SERVICE BULLETIN NO. 222A - PIPER

SUBJECT: Removal of Restriction to Air Speed Limits (Replacement of Stabilator Torque Tube)
MODELS AFFECTED: PA-30 Twin Comanches. Serials 30-1 to 30-482 incl., 30-484 to 30-491 incl., 30-493, 30-494, 30-496 to 30-502 incl., 30-504, 30-505, 30-507 to 30-565 incl.
NOTE: Serial Numbers 30-483, 30-492, 30-495, 30-503 and 30-506 have been modified at the factory and require only removal of placard and temporary supplement to flight manual for compliance.
COMPLIANCE DATE: Prior to but not later than 10 hours of operation after receipt of stabilator torque tube.

INSTRUCTIONS FOR REPLACEMENT OF TORQUE TUBE ASSEMBLY

PA-30 Twin Comanche

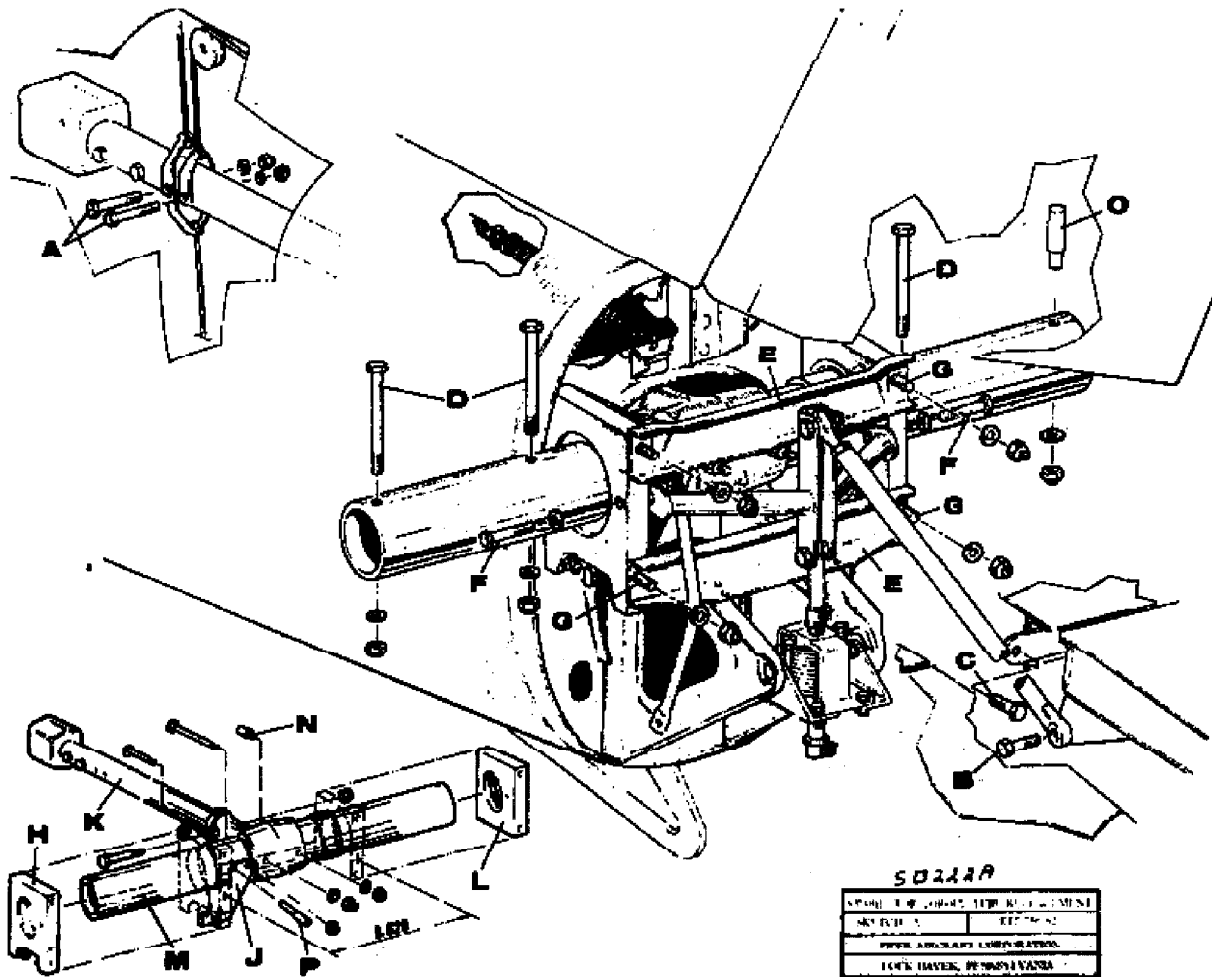
It has been determined that a stabilator torque tube, part number 22655-07, of heavier wall thickness will eliminate this vibration.

THE ORIGINAL STABILATOR TORQUE TUBE MUST BE SCRAPPED TO AVOID INADVERTENT REINSTALLATION IN PA-30 AIRCRAFT.

16. Install counterbalance arm assembly on new stabilator torque tube, part number 22655-07. Note position in View B. Item M.

Holes drilled in the torque tube assembly are undersize and will be line-reamed on assembly. Since the holes in counterbalance arm assembly and stabilizer fittings have already been reamed, a special locating pin, part number 25304-00 is included with each torque tube to insure proper fit of these assemblies. Item N.

Ream the other hole in the tube to .3120 to .3130. Insert bolt in reamed hole before removing locating pin to ream the second hole.

Ream the other hole in the tube to .2465 to .2475. Insert bolt in reamed hole before removing locating pin to ream the second hole.

Shims, part no. 81262-72, should be installed with bearing blocks in same position as when removed to maintain a dimension of 8.620 shown in View C.
